**RE: *Second Submission Review – Economy Rental Parking Expansion Filing No. 2
Site Plan Amendment and Plat
Application Number: DA-2113-01
Case Numbers: 2017-6049-02; 2023-3018-00***

COMMENT RESPONSE LETTER: SITE PLAN AND PLAT COMMENTS

ECONOMY RENTAL PARKING EXPANSION AT PORTEOS SUBDIVISION FILING NO. 2

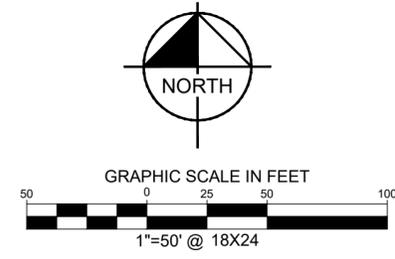
The minimum radius for a 23' fire lane radius is 29'.
The radii in the 23' wide aisles have been revised. The radii of the 26'+ entry remains as 26'.

ECONOMY RENTAL PARKING EXPANSION AT PORTEOS
 SITE PLAN - PARCEL B
 CITY OF AURORA
 OVERALL SITE PLAN

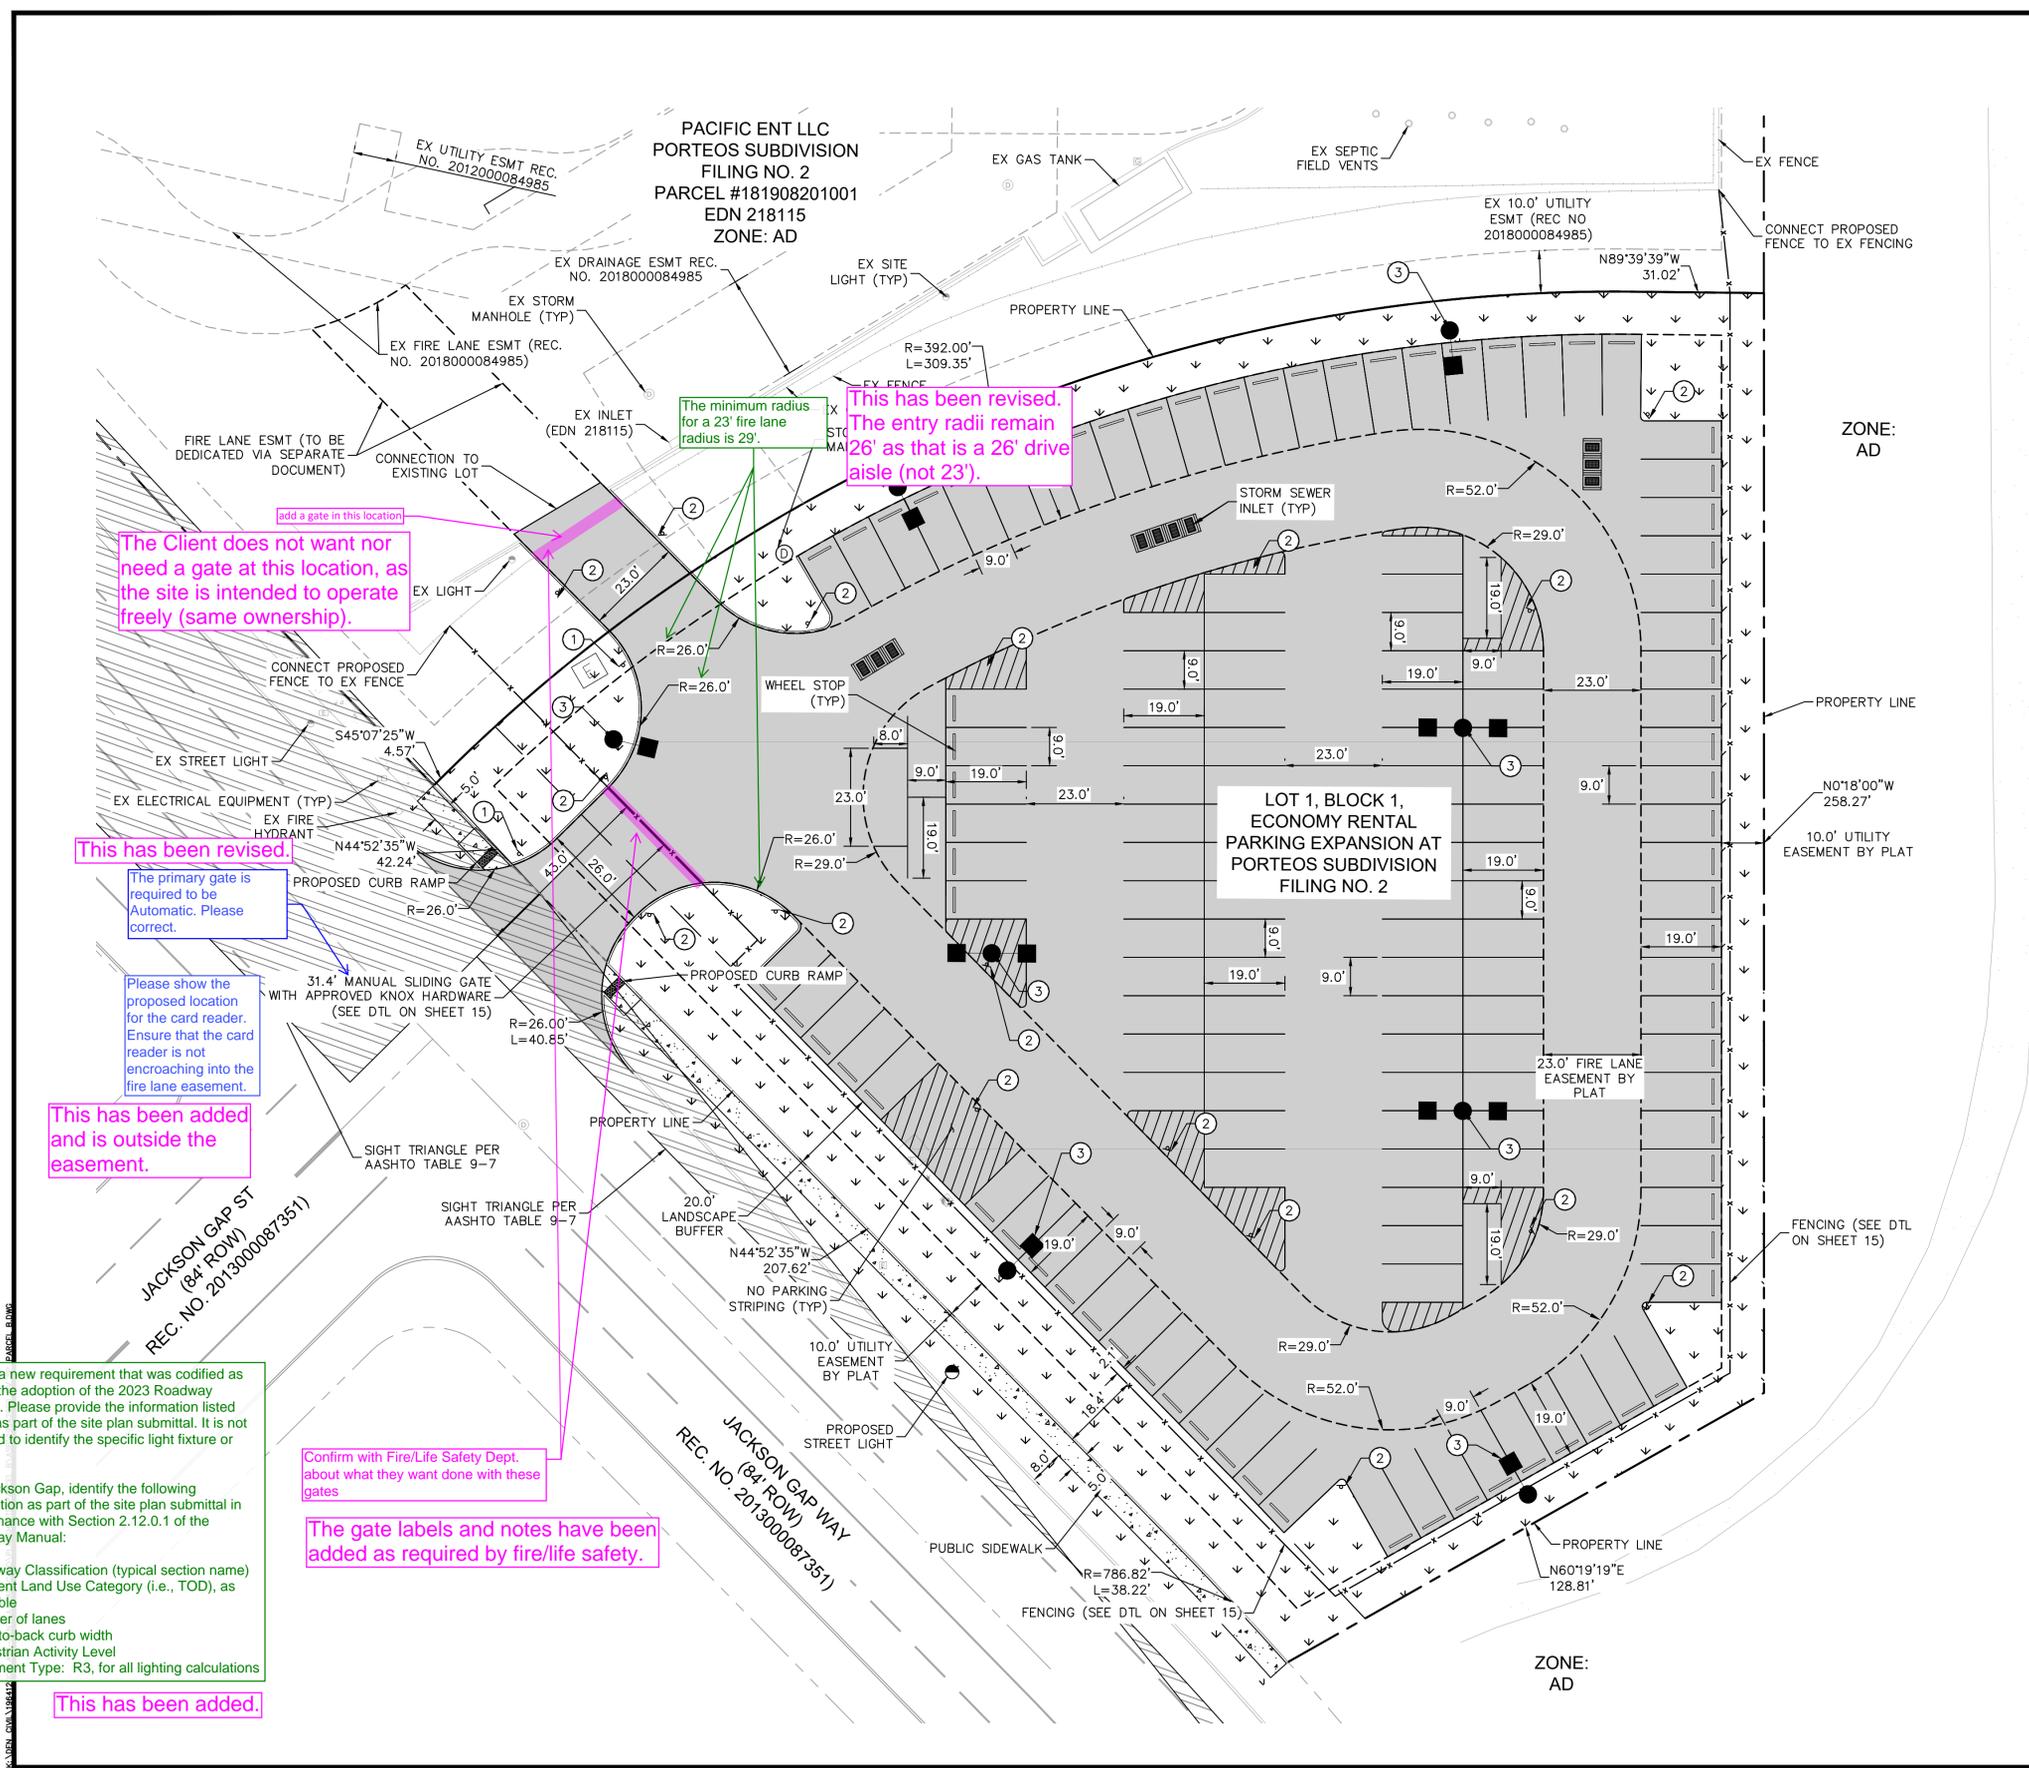
Please add the following note:
 "Proposed street light locations are conceptual. Final locations will be determined with photometric analysis submitted with the street lighting plans in the civil plan submittal."

This is a new requirement that was codified as part of the adoption of the 2023 Roadway Manual. Please provide the information listed below as part of the site plan submittal. It is not required to identify the specific light fixture or pole.

For Jackson Gap, identify the following information as part of the site plan submittal in conformance with Section 2.12.0.1 of the Roadway Manual:

- Roadway Classification (typical section name)
- Adjacent Land Use Category (i.e., TOD), as applicable
- Number of lanes
- Back-to-back curb width
- Pedestrian Activity Level
- Pavement Type: R3, for all lighting calculations

This has been added.

This has been added.

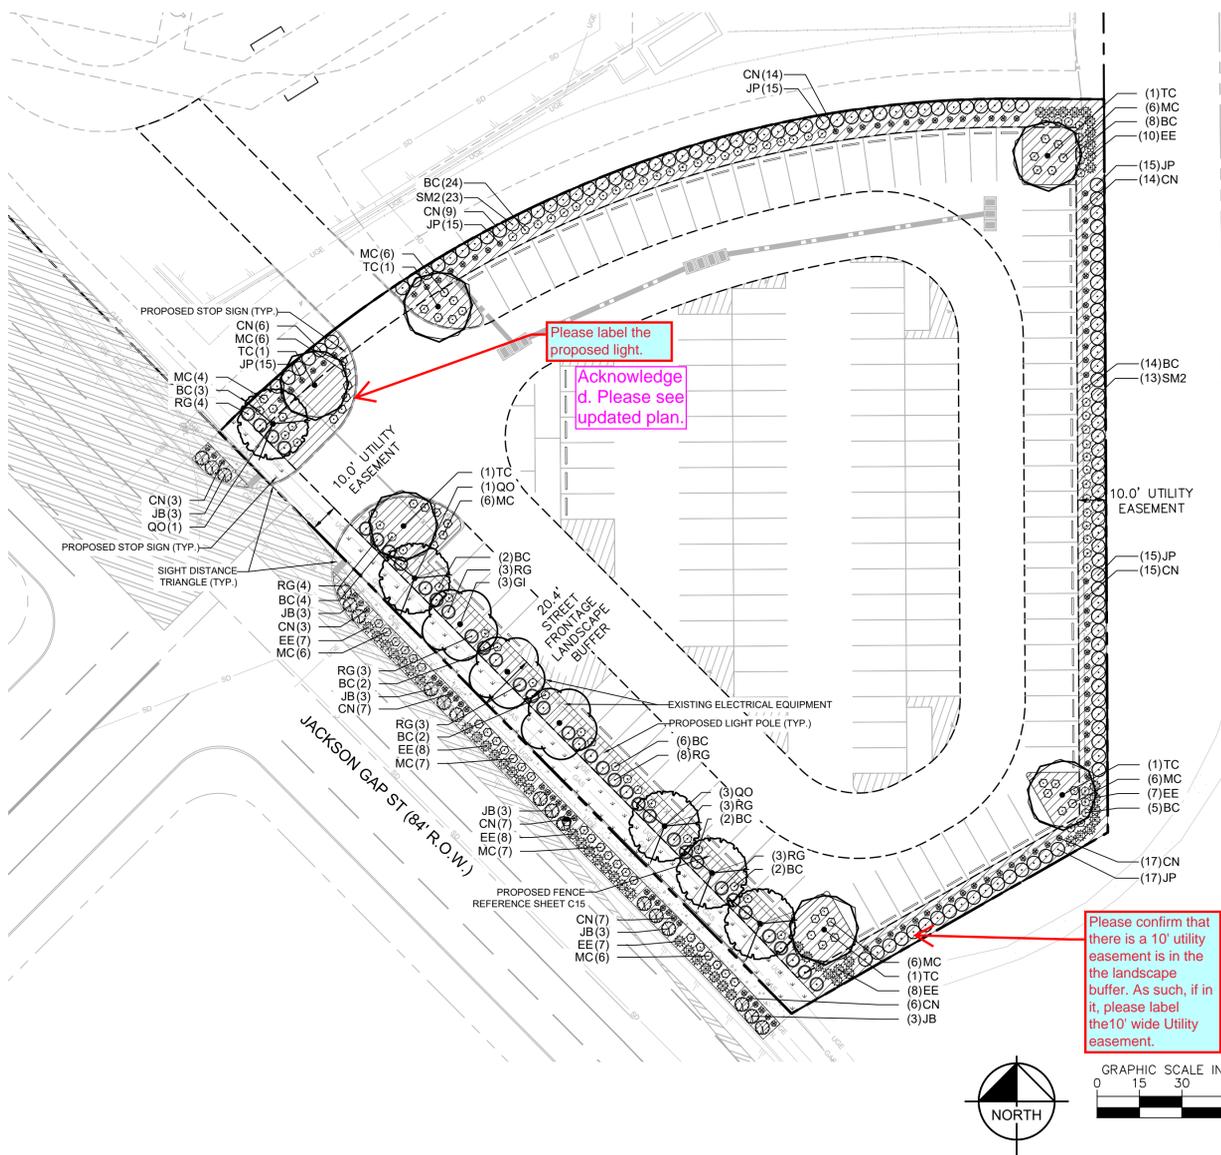
Confirm with Fire/Life Safety Dept. about what they want done with these gates

The minimum radius for a 23' fire lane radius is 29'.
 This has been revised. The entry radii remain 26' as that is a 26' drive aisle (not 23').

The gate labels and notes have been added as required by fire/life safety.

This has been revised.

The Client does not want nor need a gate at this location, as the site is intended to operate freely (same ownership).
